## Exhibit #4

### Paper circulated to World Council in August 2019 – first part

#### 1. Position of the jib tack

#### Older design

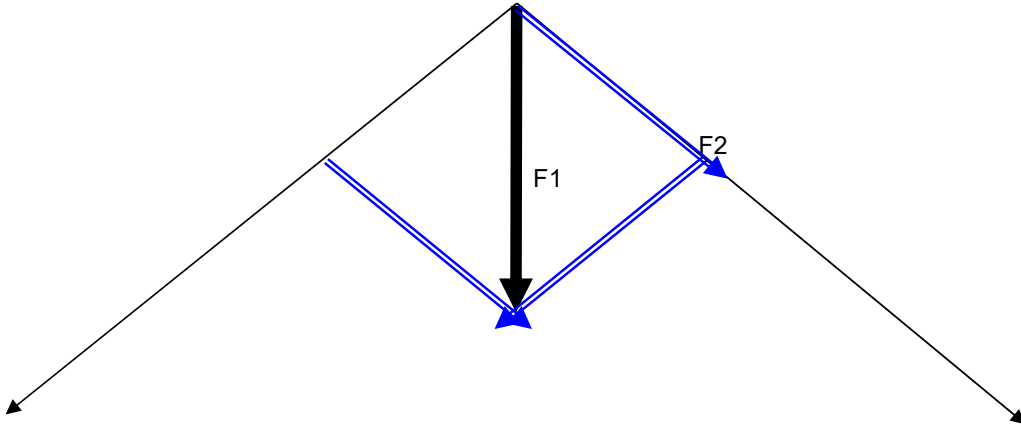
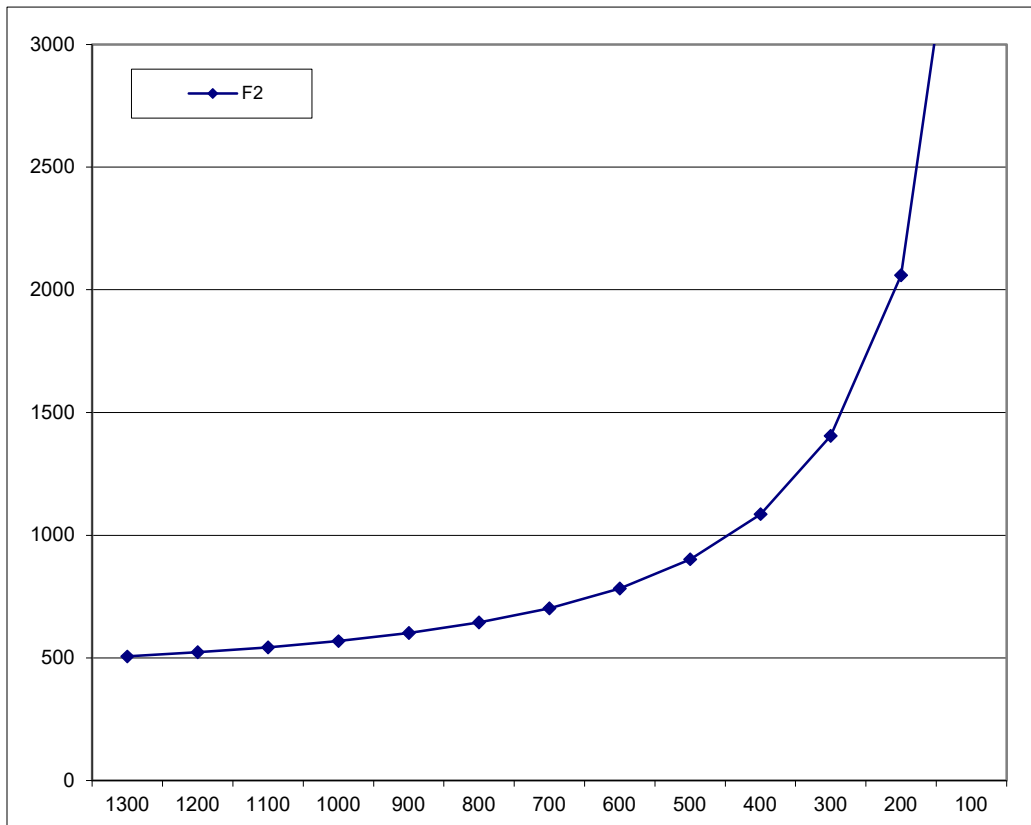
- Lowering the position of the jib improves performance:
  - Improves efficiency of the jib (horizontal foot)
  - Accelerates airflow over lower section of the (decksweeper) mainsail
  - Lowers the center of effort
- Over time, to improve performance while staying within rule C.10.3(b) builders have lowered the apex of the forestay bridle

- Lowering the apex increases the loads exercised by the bridles on the hull attachment points. This causes hull construction challenges and reduces longevity of the hulls.

- to lower the jib tack without further increasing the loads on the bridle attachment points. The jib tack will be set on the bowsprit (as on the Tornado)
- for builders to redeploy material to other parts of the hulls, increasing stiffness and longevity

- Retro-fitting is straightforward:
  - New jib (different geometry, luff zip)
  - Extra compression tube (e.g. carbon or aluminium) set between the bridle apex and the bowsprit to allow tensioning of the jib luff (similar to Tornado)
- Impact class rules:
  - Remove rule C.10.3(b)
  - Add the compression tube as a permitted equipment item (optional material)
